Radiation Shielding Calculations

PET/CT-Room D-313

MIAMI VA HEALTHCARE SYSTEM

**May 27, 2015
(Revised 09/18/15)**

Figure 1. PET/CT DIAGRAM

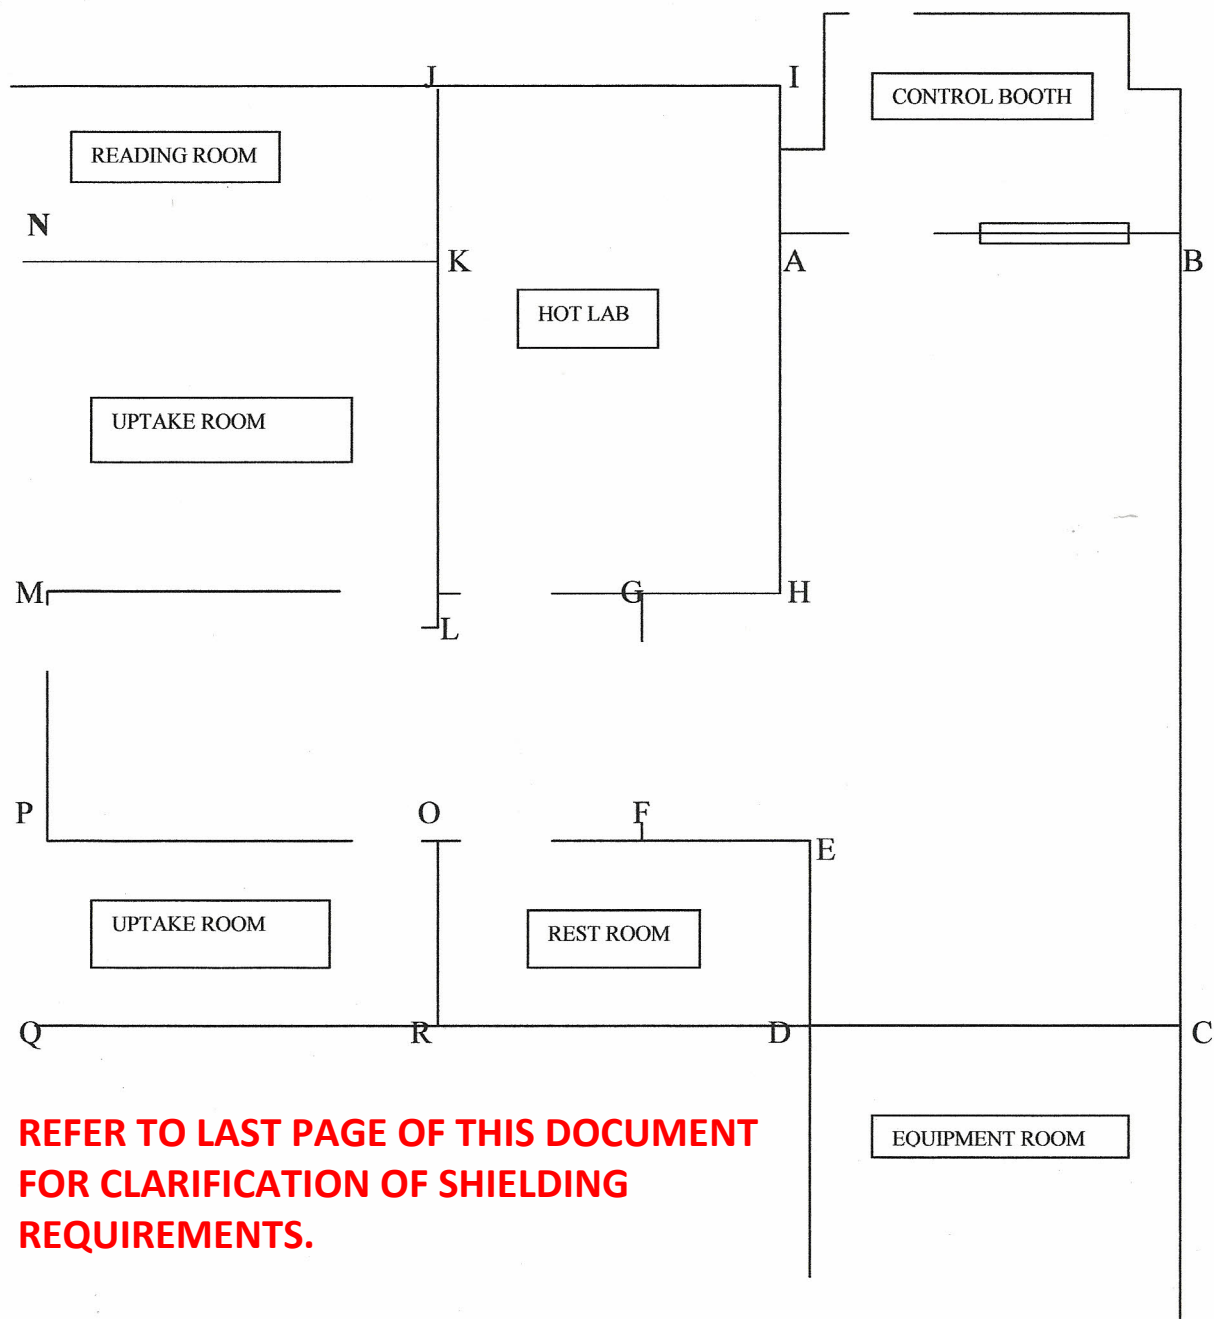
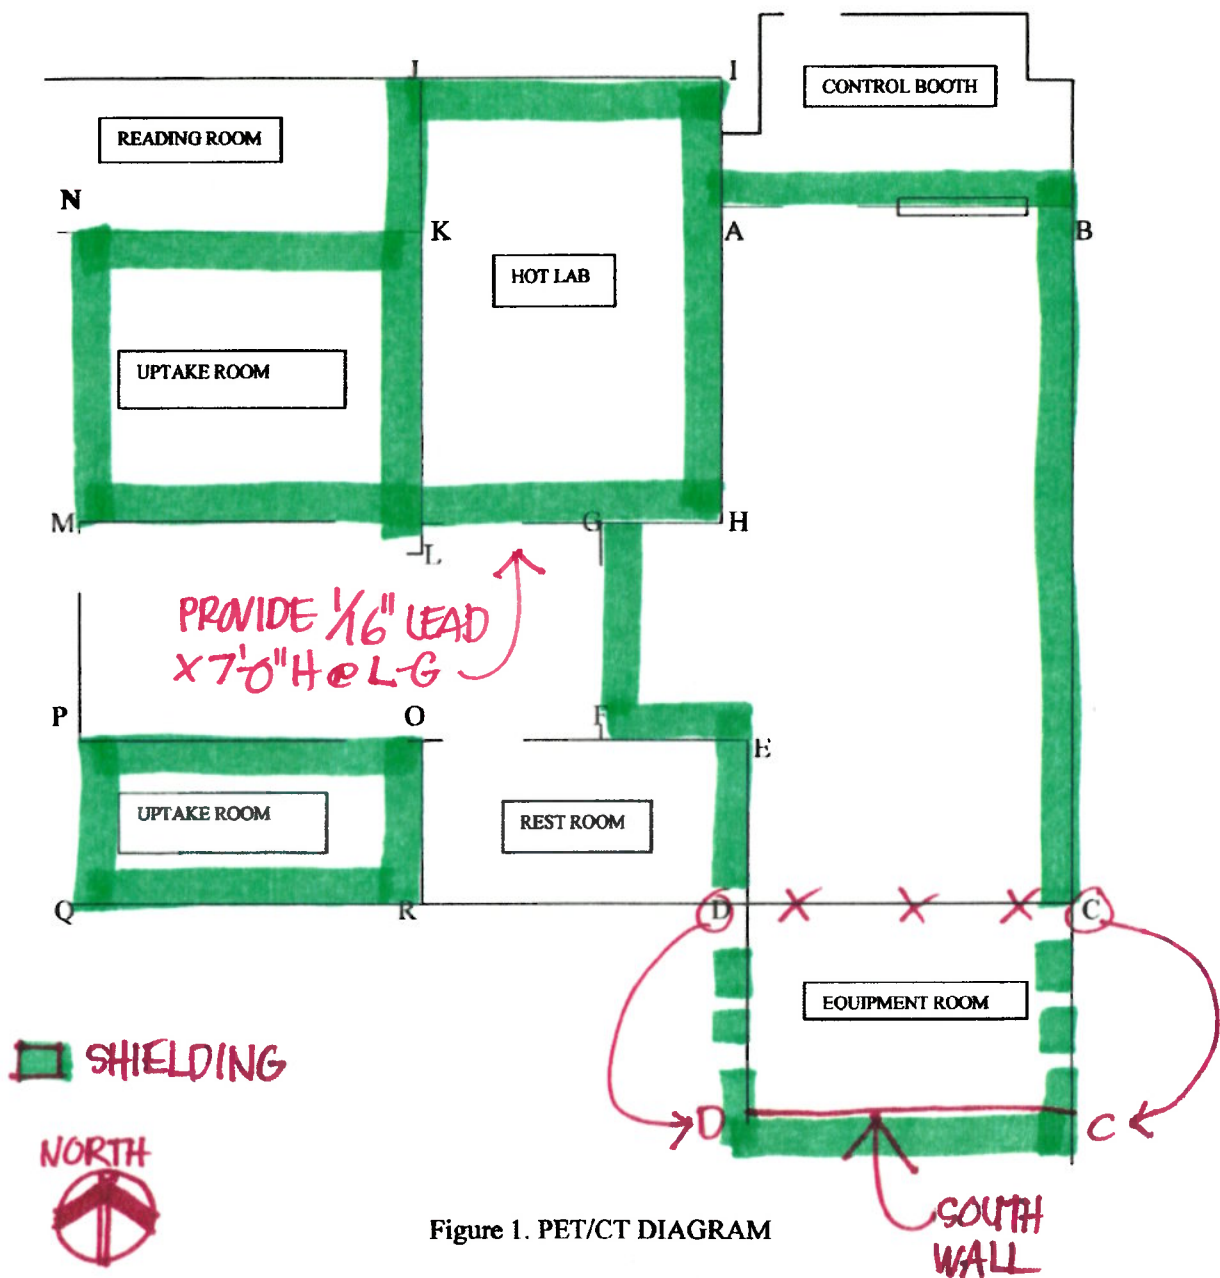
1. Shielding for Wall BC and Wall ED should extend to South Wall of Equipment Room as marked.
2. Shielding for Wall CD should be installed in South Wall of Equipment Room as marked. The hinged pair of glass doors in the North Wall of the Equipment Room cannot be shielded in a cost effective manner.
3. Please confirm that Radiation Consulting Associates, Inc. concurs with these comments.

1. Shielding for Wall BC and Wall ED should extend to South Wall of Equipment Room as marked.
2. Shielding for Wall CD should be installed in South Wall of Equipment Room as marked. The hinged pair of glass doors in the North Wall of the Equipment Room cannot be shielded in a cost effective manner.

3. Please confirm that Radiation Consulting Associates, Inc. concurs with these comments. **RCA Concurs.**
